## CITY of NOVI CITY COUNCIL

**Agenda Item 2**  
**March 11, 2013**

**SUBJECT:** Preliminary approval of the request of Toll Brothers, Inc. for The Meadows of Island Lake of Novi JSP12-65, for inclusion of the subject property into the existing Island Lake of Novi Residential Unit Development (RUD), and modifications to the RUD concept plan. The subject property is 40.68 acres of land located near the northeast corner of Ten Mile Road and Wixom Road. The applicant is proposing a 74 unit single family development that would be Phase 7 of the existing Island Lake of Novi development.

Title:  
**Woodland Plan**

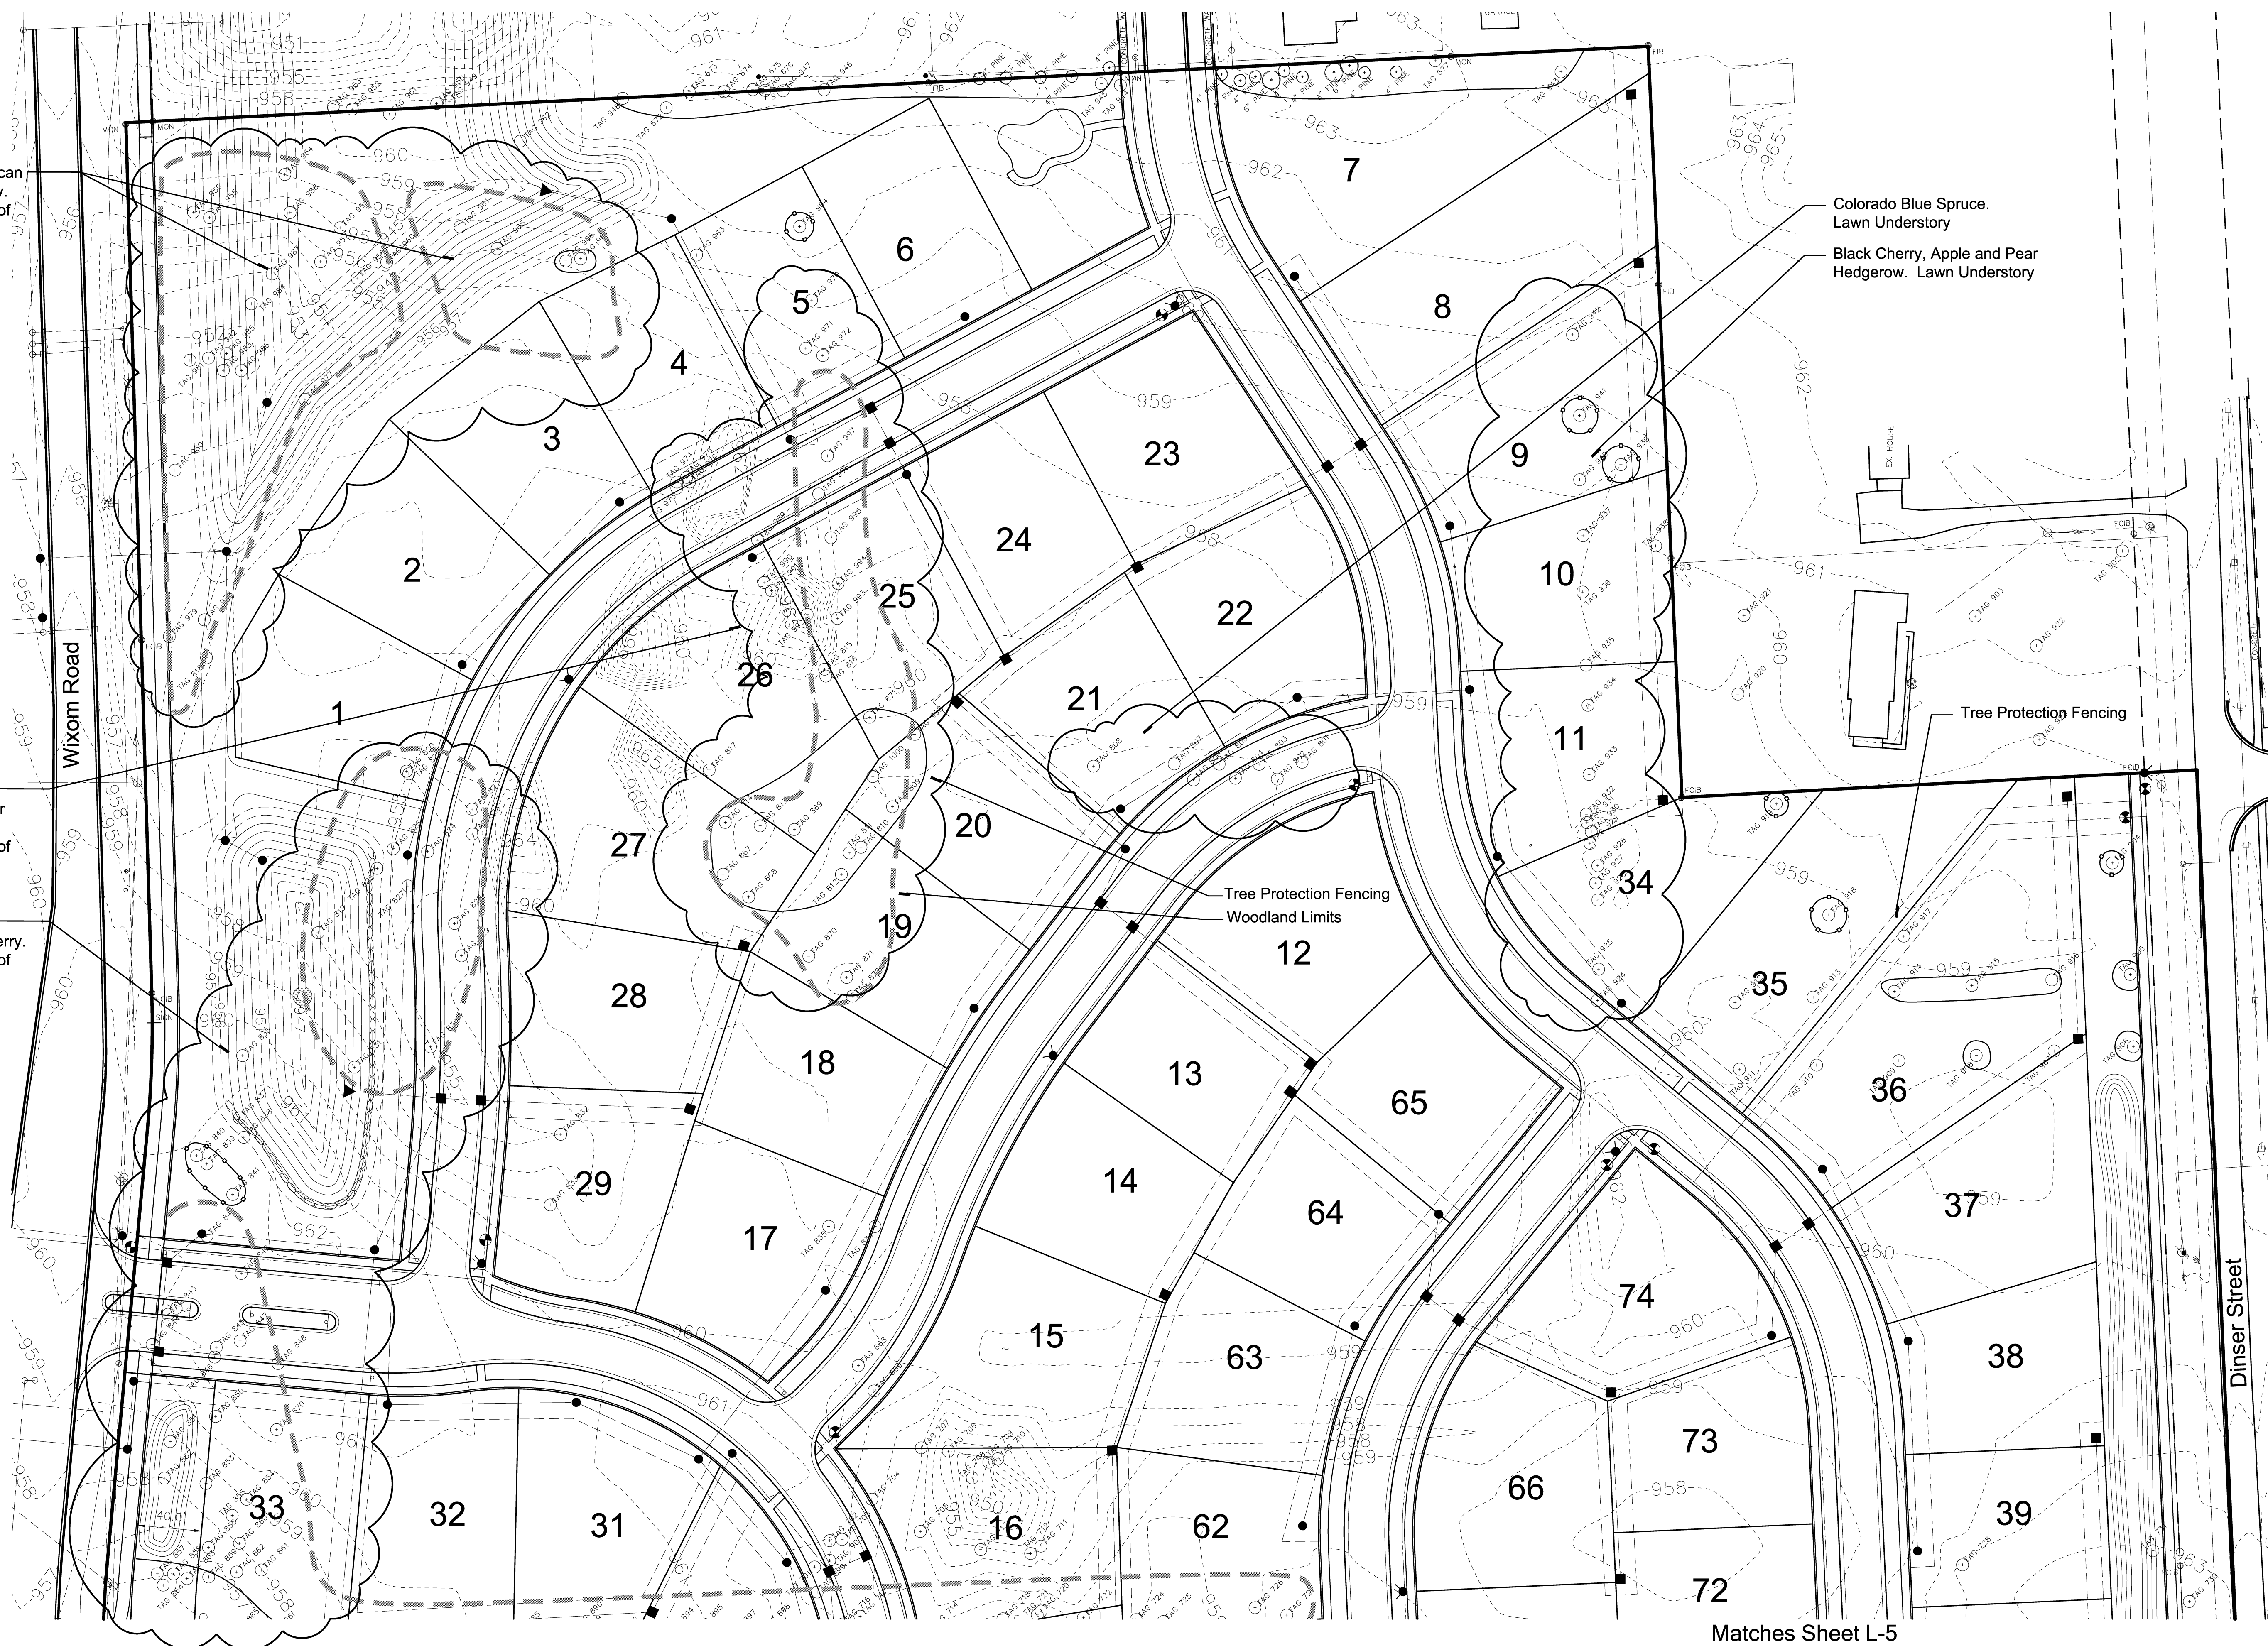
Per summary calculations on the *Woodland Plan* (Sheet L-5), the current Plan proposes the removal of 143 live trees with d.b.h. greater than or equal to 8 inches, requiring a total of 220 replacement credits. The Plan states that 180 Woodland Credits can be achieved via preservation of Non-Woodland Trees. This results in a total of 40 Woodland Replacement Trees required, according to the Plan.

After review of the *Tree List* (Sheet L-6), ECT tallied a total of 141 regulated trees to be removed (several of these trees have multiple stems). In addition, ECT tallied a total of 220 Woodland Replacement Trees required. This is consistent with the quantity shown on the *Woodland Plan* (Sheet L-5).

The Plan is seeking a total of 180 Woodland Replacement Credits for the preservation of Non-Woodland Trees. This information is found on the *Tree List* (Sheet L-5). Based on our tally of 220 Woodland Replacements required, less the 180 Woodland Credits of Non-Woodland Tree Preservation, it appears as though the Applicant would be responsible for a total of 40 Woodland Replacement Trees. Currently, the Plan appears to propose 30 Woodland Replacement trees (8 sugar maple, 8 tulip tree, 7 red oak and 7 silver linden) to be located around the Proposed Detention Basin No. 1 in the northwest corner of the property. It is currently not clear where the remaining 10 required Woodland Replacement Tree requirements will be planted, or if the Applicant intends to pay into the City of Novi Tree Fund for the remaining required credits.
